DP50749-01

Notice

Category: COLOR TELEVISION Date: OCTOBER / 29 / 2009
 Model: DP50749 Effective from : Chassis No. P50749-01
 Destination: U.S.A. / CANADA REF : No. SM780163-01

Logic Board

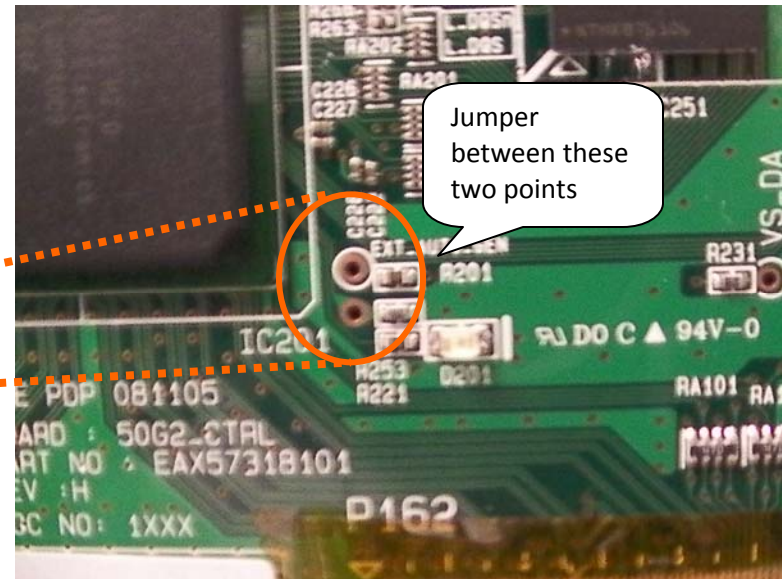
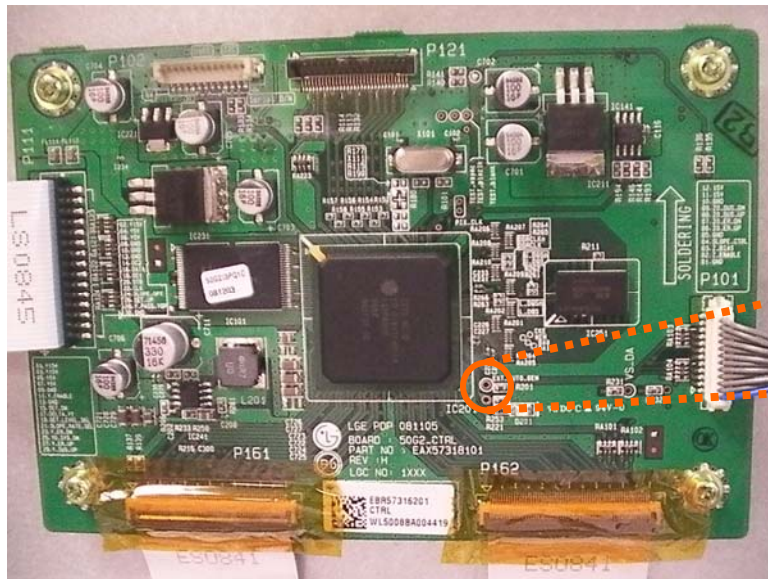
2) Short the pins together on Logic Bd. (drawing attached)

For Panel Self Test to Run:

- 1) Must unplug LVDS Cable between Main Bd. & Logic Bd..
- 2) Must unplug cable between Pwr Bd. (P813) and Main Bd. (K8P & K8B)
- 3) Short the above two points on the Logic Bd.

1. SVC Guide for Black Half Image (PDP50G2T000)

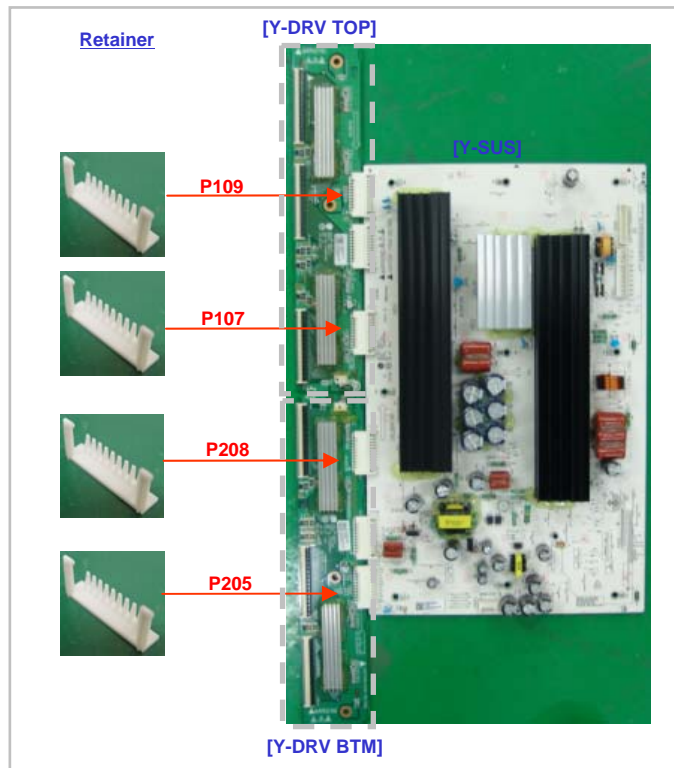
: Black half image or Abnormal half image

: insufficient connection between Y-DRV B/D and Y-SUS B/D

- 1) Insert Retainer 4EA in Y-DRV B/D Connector
- 2) Retainer Part Number: **EAG61050702**
- 3) **Y-DRV B/Ds don't need to be replaced.**
- 4) **If Y-DRV failure occurs,**
normal Y-DRV and retainer should be replaced.

- 1) Connect Y-DRV and Y-SUS B/D
- 2) Insert and push the retainer until click sound is heard.
